# Memorandum

Project	Kawarau (VHR H0489)		
Subject	Response to P41747 RFI Item No. 2	Date	15/06/2026
Location	405 Tooronga Road, Hawthorn East

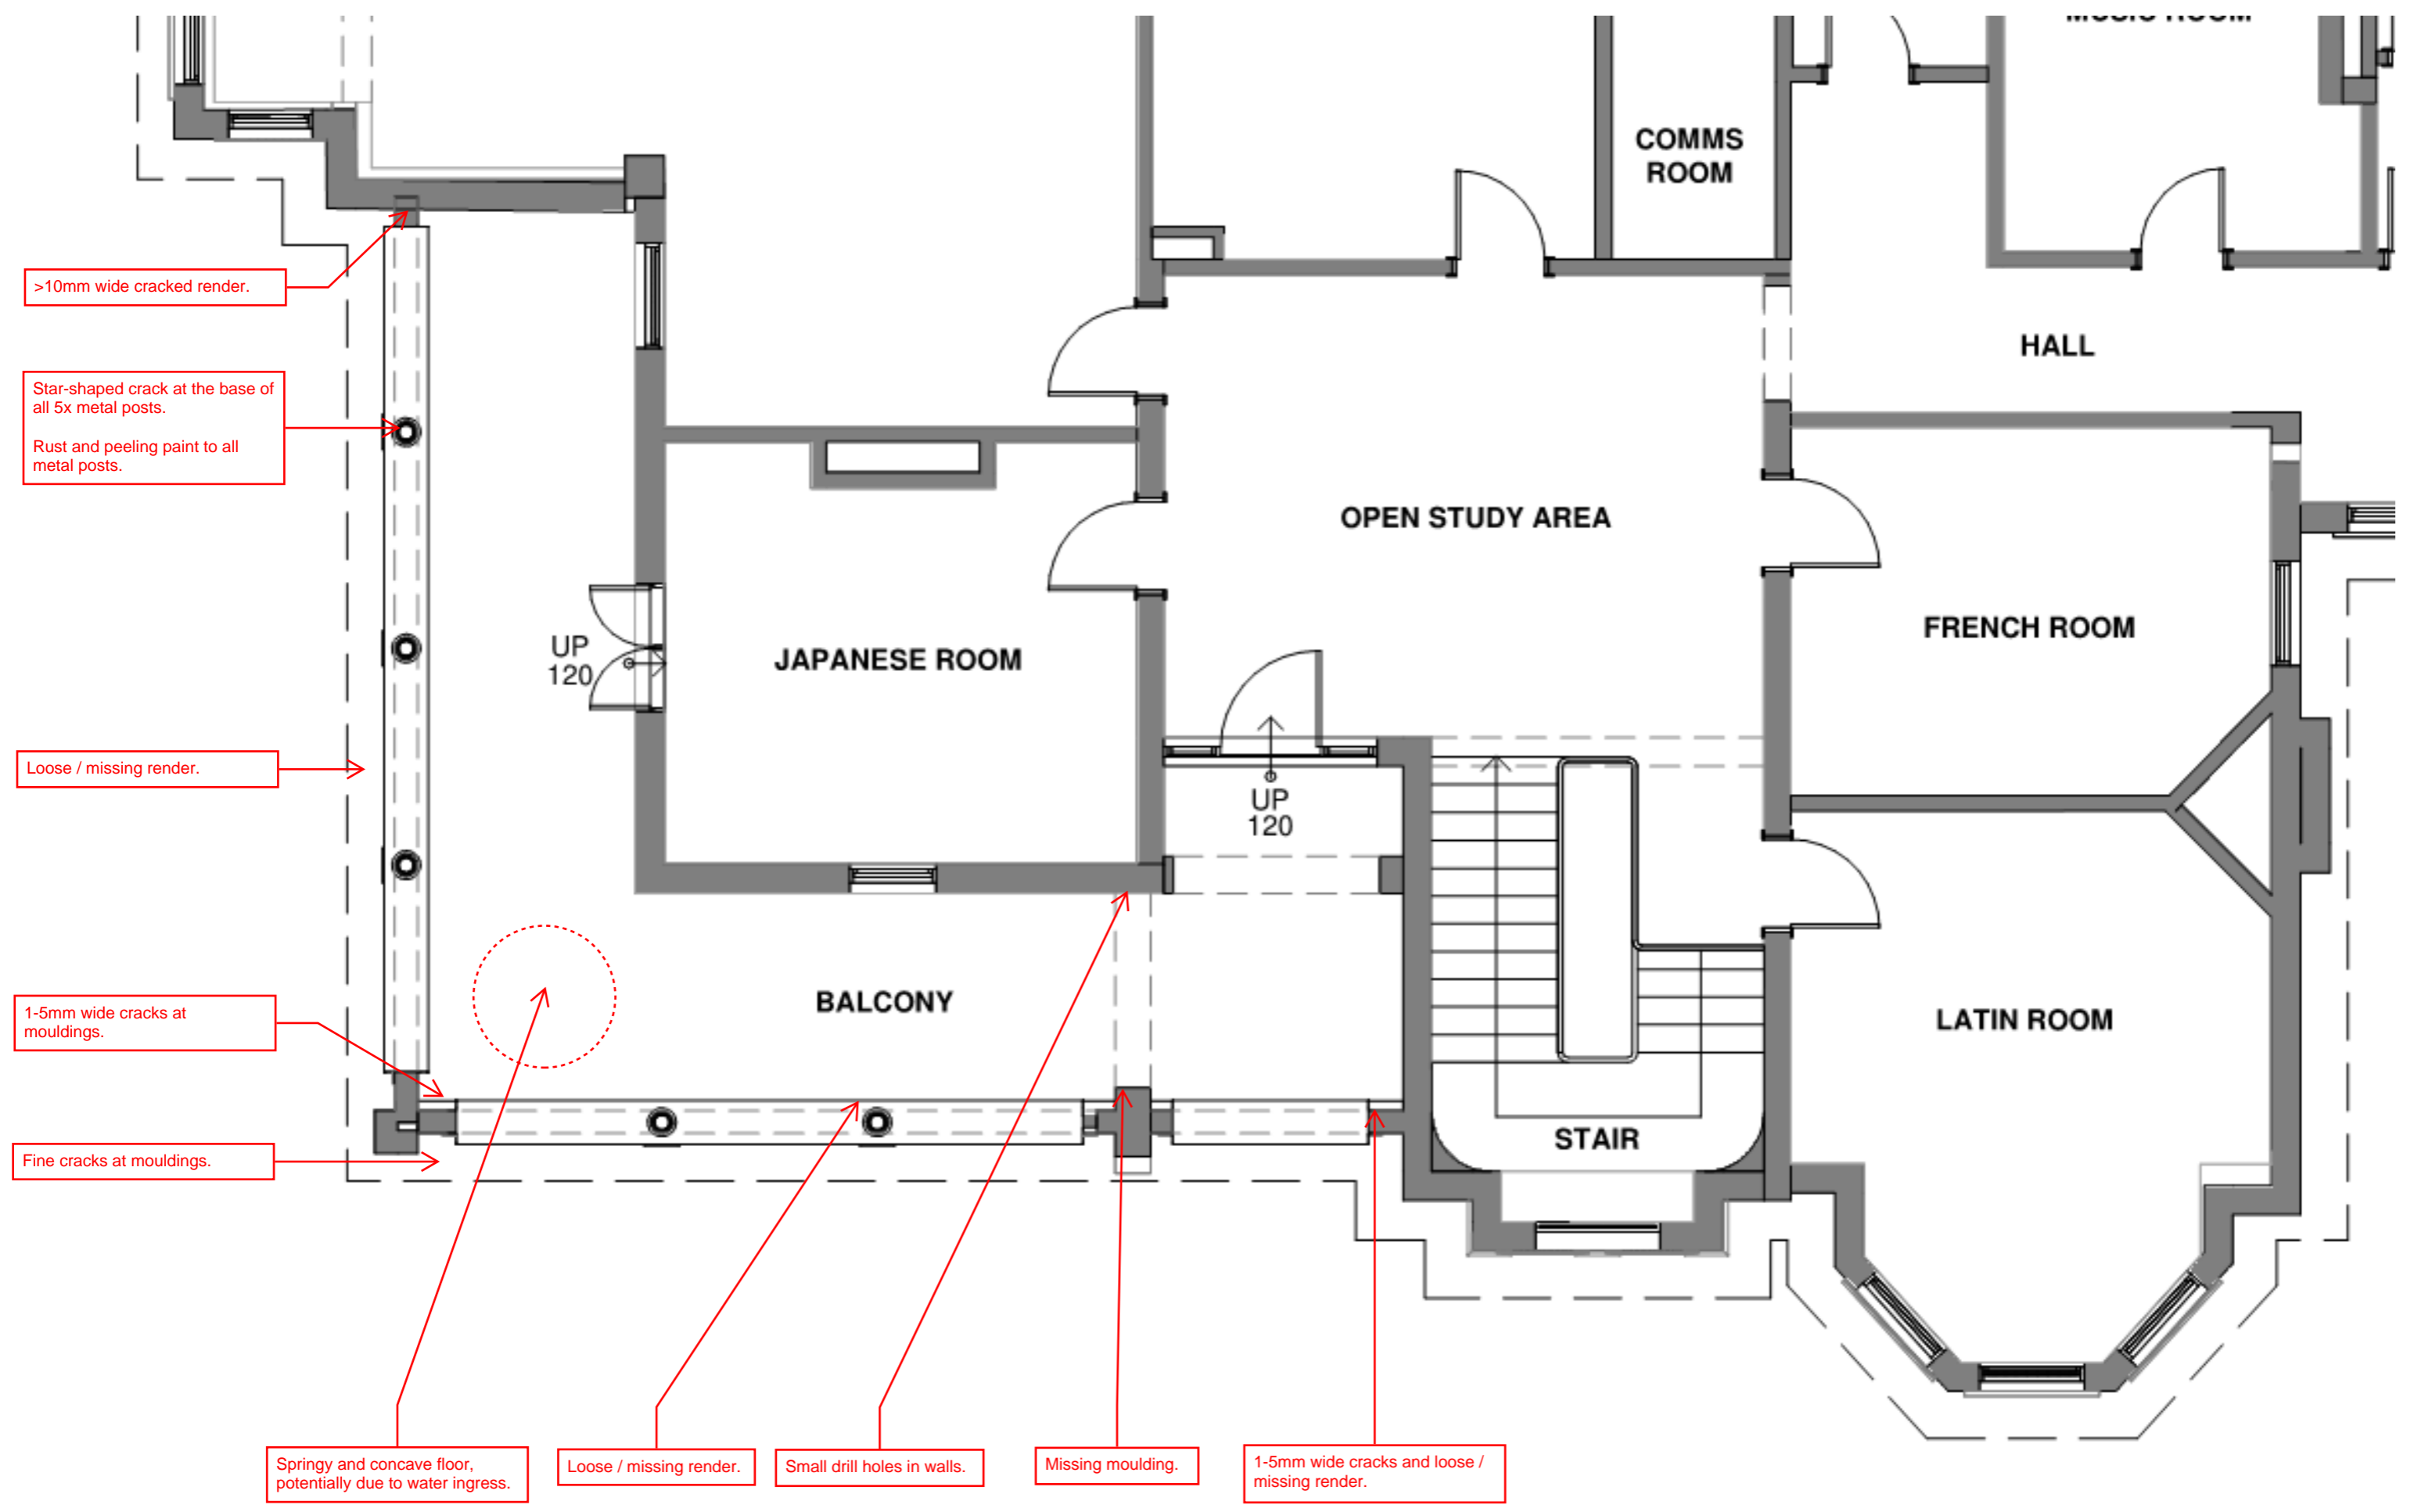
Affected Area	Observations	Photos	Proposed Conservation Actions
Walls	Small drill holes (approx. 5mm in diameter) are observed throughout. Loose and missing render at some areas, exposing red bricks underneath.		Engage a structural engineer to assess the identified areas and confirm whether there is any safety risk associated with loose render.  Remove defective, drummy, or loose render and replace with new. The defective area is to be stripped back to sound substrate. If substrate is found to be loose or

Painted metal posts	Rusting posts and peeling paint.		<p>Repair or restoration is not generally considered where damage is minor, and works should only cover what is necessary to maintain or restore functionality.</p> <p>Where necessary, clean the posts carefully and by hand to remove any rusts and peeling paint. After cleaning, prime with a zinc chromate or other appropriate metal primer and apply a full paint system in accordance with the paint manufacturer's specification.</p>

<p>Balustrade</p>	<p>Cracked concrete throughout. Specifically, star-shaped cracks radiating from the base of all cast iron columns are identified.</p>		<p>Engage a structural engineer to assess the identified areas and confirm whether there is any safety risk associated with cracking.</p> <p>Surface treatment would involve removing defective, drummy, or loose render and replace with new. The defective area is to be stripped back to sound substrate. If substrate is found to be loose or crumbling, it shall be generally repaired and replaced prior to repair of render.</p> <p>New render must match the existing in the composition of render mix, colour, finish, and moulding details (where applicable). Surfaces to be re-rendered shall be free from dirt, paint, oil, or other loose particles.</p>
<p>Gutters</p>	<p>Appears to be lead gutters and tin flashings. They are generally in good condition but are loose at certain areas.</p>		<p>Refix gutters where required.</p>

<p>Mouldings</p>	<p>Cracked render throughout. At some areas, red bricks are exposed due to missing render.</p>		<p>Remove defective, drummy, or loose render and replace with new. The defective area is to be stripped back to sound substrate. If substrate is found to be loose or crumbling, it shall be generally repaired and replaced prior to repair of render.</p> <p>Re-running of all lost moulded render should be undertaken in-situ to match profile and finish of adjacent mouldings.</p> <p>Repairs should be undertaken by an experienced tradesperson using traditional skills.</p>

Floor	<p>The floor is covered over with non-original mats, and the floor's material and construction are unknown at this stage. However, floor may be of timber construction.</p> <p>Area at the southwestern corner has a visible indentation and is springy to touch, suggesting that there may be water damage.</p>		<p>Investigate source of water ingress and rectify as required.</p> <p>Remove mat for further inspection.</p> <p>If floor structure is confirmed to be timber, remove sections of rotten, damage, or otherwise degraded timber beyond reasonable repair and splice in new sections.</p> <p>Care is to be taken to ensure the new section matches the existing including in timber species, cut, size, grading, and profile.</p>
-------	--	---	---

<p>crumbling, it shall be generally repaired and replaced prior to repair of render.</p> <p>New render must match the existing in the composition of render mix, colour, finish, and moulding details (where applicable).</p> <p>Surfaces to be re-rendered shall be free from dirt, paint, oil, or other loose particles.</p>
Columns	Cracks, loose, or missing render. Some cracks are >5mm and pulling away from the balustrade.	 	<p>Engage a structural engineer to assess the identified areas and confirm whether there is any safety risk associated with cracking.</p> <p>Surface treatment would involve removing defective, drummy, or loose render and replace with new. The defective area is to be stripped back to sound substrate. If substrate is found to be loose or crumbling, it shall be generally repaired and replaced prior to repair of render.</p> <p>New render must match the existing in the composition of render mix, colour, finish, and moulding details (where applicable).</p> <p>Surfaces to be re-rendered shall be free from dirt, paint, oil, or other loose particles.</p>
